**From:** Chris Ciz  
**Sent:** Thursday, December 19, 2013 1:39 PM  
**To:** All Dirs All Rgns - PT; All Dirs All Rgns - SR  
**Subject:** MAZDA DEALER NOTICE - SERVICE BULLETIN RELEASE

09-038/13 - 2014 MAZDA3 (WITH MAZDA CONNECT) - VARIOUS AUDIO SYSTEM CONCERNS WITH TUNER AND AMP UNIT (TAU)

<b>Subject:</b> VARIOUS AUDIO SYSTEM CONCERNS WITH TUNER AND AMP UNIT (TAU)	<b>Bulletin No:</b> 09-038/13
	<b>Last Issued:</b> 12/19/2013

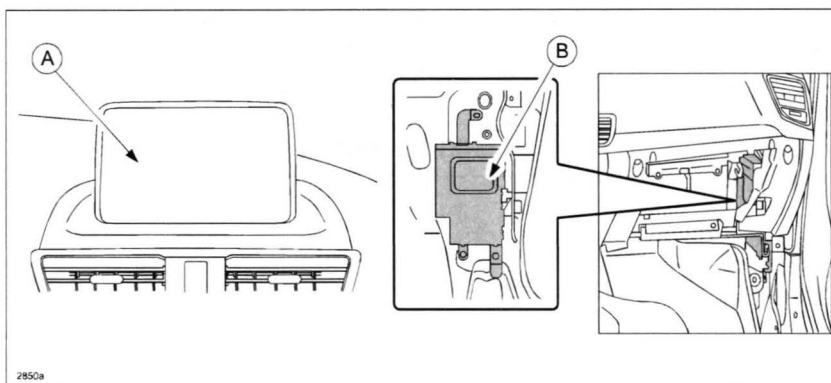
Some vehicle may experience any one of the symptoms below that can be resolved with a modified TAU.

- AM/FM/XM cannot be selected as they are grayed out
- Radio station returns to 87.9MHz on its own
- Audio sound setting resets on its own
- TAU version is displayed as "not available"

1. Verify customer concern.
2. On vehicle with a touchscreen (A), remove the TAU (B) and replace with a modified one. Refer to MS3 online instructions or Workshop manual (section 09-20 TUNER AND AMP UNIT (TAU) REMOVAL/INSTALLATION).
